## **SECTION 3**

# **MASTER RESPONSES TO COMMENTS ON DRAFT REIR (DECEMBER 2004) AND RECIRCULATED DRAFT REIR (FEBRUARY 2006)**

## **MR-1: Biological Resources Impacts: Mitigation Revisions and Clarifications**

Figure 2: Groundwater Elevations from Carmel Valley Aquifer Wells Upstream of September Ranch

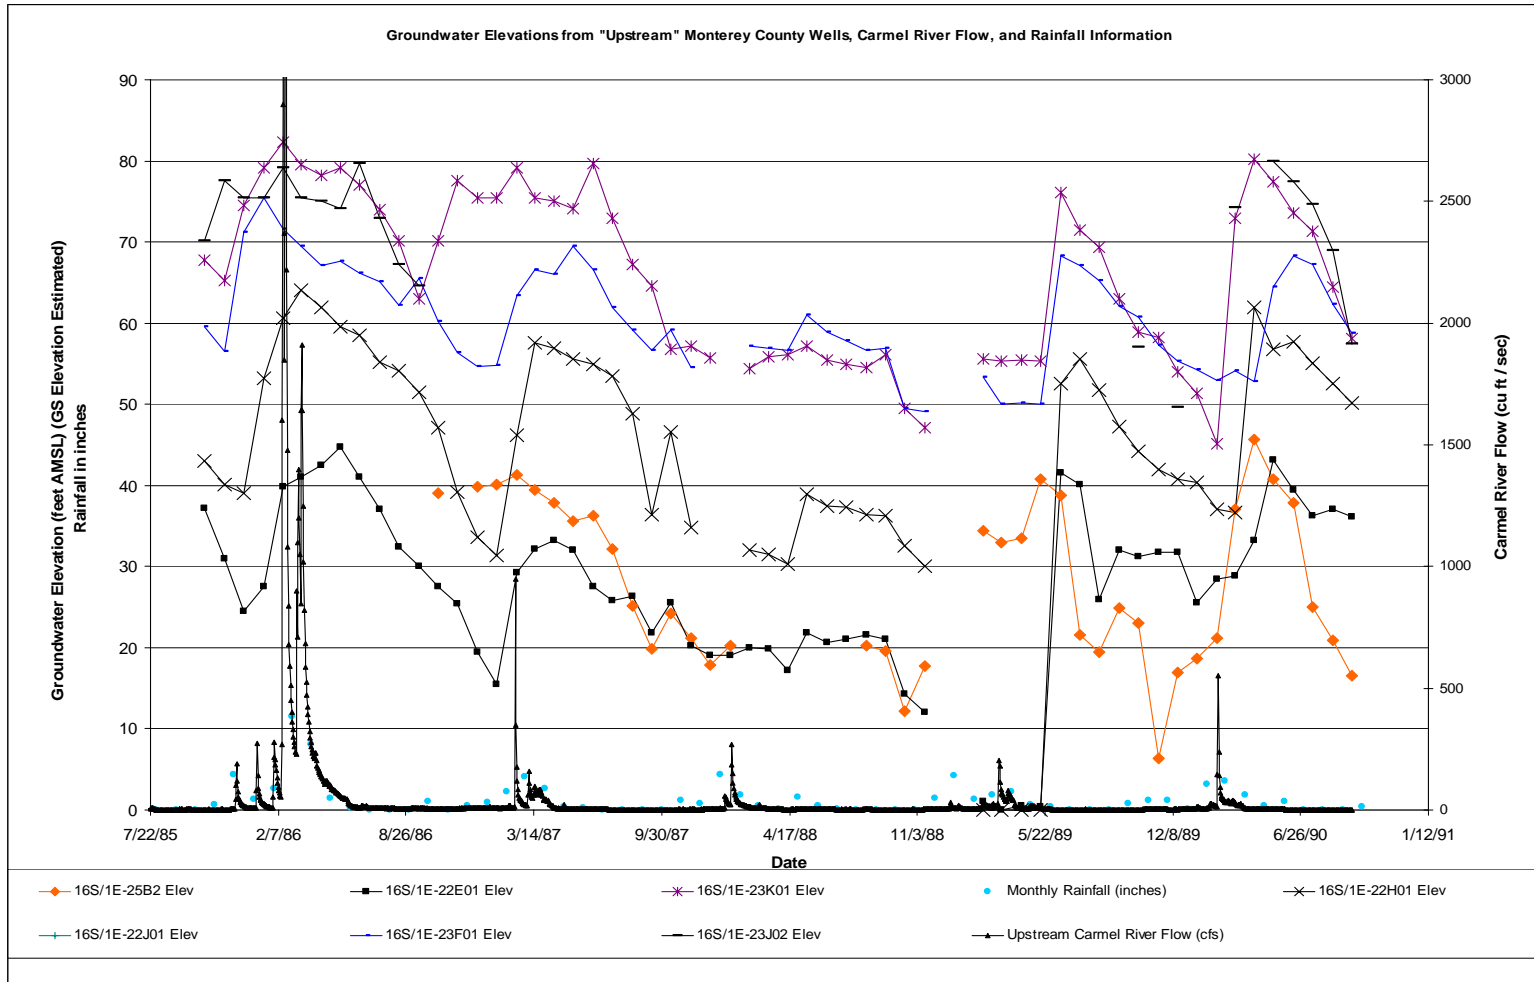
The discussion presented herein is intended to respond to those requests by clarifying and providing additional analysis to support the conclusion that the CVA efficiently refills during and after drought periods. Based on groundwater elevation data provided by the Monterey County Water Resources Agency (5 February, 2004 from R. Johnson), groundwater levels immediately upstream of the SRA in the CVA AQ3 (Figure 2 TM-7, in wells 16S/1E25-B02, 16S/1E22-E01, 16S/1E22-H01, 16S/1E22-J01 [no data from 1985 on], 16S/1E23-J02, 16S/1E23-F01, and 16S/1E23-K01) do recover during the critically dry period of 1987 to 1991 to their pre-drought levels. Groundwater recoveries during this extended and critically dry period are nearly completely the same as the groundwater elevations (Figure 2) during normal rainfall years; moreover, recoveries occur consistently during the winter and spring months (February through May) in a water year.

Significance of impact should also account for *depleted groundwater storage* over the drought period at issue. KJC agrees with the District's comment that there was a notable depletion of perennial groundwater storage from 18,979 AF (1986) to 14,286 AF (1990) in AQ3 during the critically dry years of 1986 to 1991 (MPWMD CVSIM3). The historical average yearly water in storage in AQ3 is approximately 16,927 AFY and the high value of water in storage of 18,979 AF in 1986 was due to a particularly wet winter in 1986 which was followed by a dry summer and the beginning of the extended dry period. Even assuming the District's proposed worst case scenario of 270 AF, the average water in storage during the five year dry period is 16,745 AFY. A reduction of recharge by the Project of 270 AF, which is overly conservative as described below, then represents 1.5 percent of total water in storage over this time period in AQ3 which is considered insignificant even for reduced storage caused by prolonged below normal precipitation condition.

The replenishment of the CVA AQ3 and hence the variations of water levels discussed above is primarily dependent on surface recharge by the Carmel River and percolating into groundwater and secondarily by subsurface inflow from the upgradient AQ2 unit. Subsurface inflow according to CVSIM information is fairly steady at 2,781 AFY; hence, groundwater level fluctuations are then primarily a response to surface recharge by the Carmel River.

CVSIM data show that the historical average yearly surface recharge is 8,000 AFY. The averaged yearly recharge between 1987 and 1991 is 7,000 AFY or 35,000 AF over five years. Recharge dropped from 7,451 AF in 1986 to 5,476 AF in 1987 followed by a slight rise of 6,176 AF of recharge in 1988. A notable rise in groundwater recharge during this critically dry period of 7,383 AF occurred in 1989 followed by a repeating low recharge of 5,396 AF in 1990. Surface recharge then again achieved a high during 1991 of 10,370 AF. The cyclical pattern of rise and fall of subsurface recharge is consistent with the groundwater level fluctuations shown in hydrographs presented in the attached Figure 2 in this response (reference Figure 2 TM-7). Groundwater responded efficiently to the combined surface and subsurface recharges in the drought period of 1987 to 1991.
